Water Right Conditions Tracking Slip

FILE # # G-17519

PUBLIC INTEREST REVIEW FOR GROUND WATER APPLICATIONS

SUBJECT: Application G- 17519 Supersedes review of 2/2/2012
Date of Review(s)

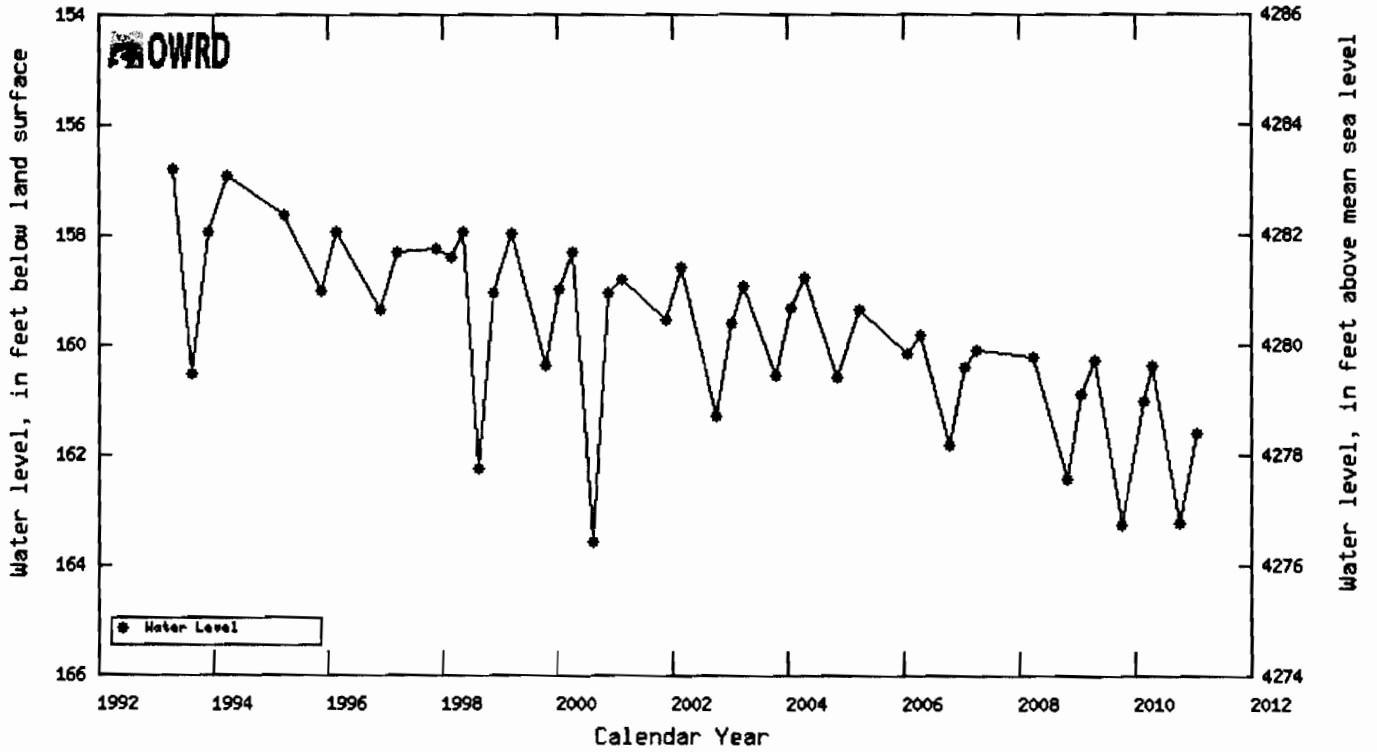
B3. Ground water availability remarks: **SEVERAL HIGH YIELDING (1800 – 2600 GPM) WELLS ARE LOCATED OR PLANNED IN THE VICINITY OF THE WELLS ON THIS APPLICATION. TWO PERMITS HAVE RECENTLY BEEN ISSUED TOTALLY 6.25 CFS IN CLOSE PROXIMITY (1-2 MILES) TO THE PROPOSED WELLS IN THIS APPLICATION. THE CLOSEST STATE OBSERVATION WELL IS LOCATED ABOUT 2 MILES TO THE NORTHEAST. THE WELL DESC 55145 HAS A SIMILAR TREND AND HAS DECLINED ABOUT 2.7 FEET SINCE 2004.**

CONDITION 7N MAY BE MODIFIED TO ALLOW ANNUAL WATER LEVEL MEASUREMENTS FROM A SMALLER SUBSET OF WELLS IF A SUBSEQUENT PLAN IS APPROVED BY THE DEPARTMENT.
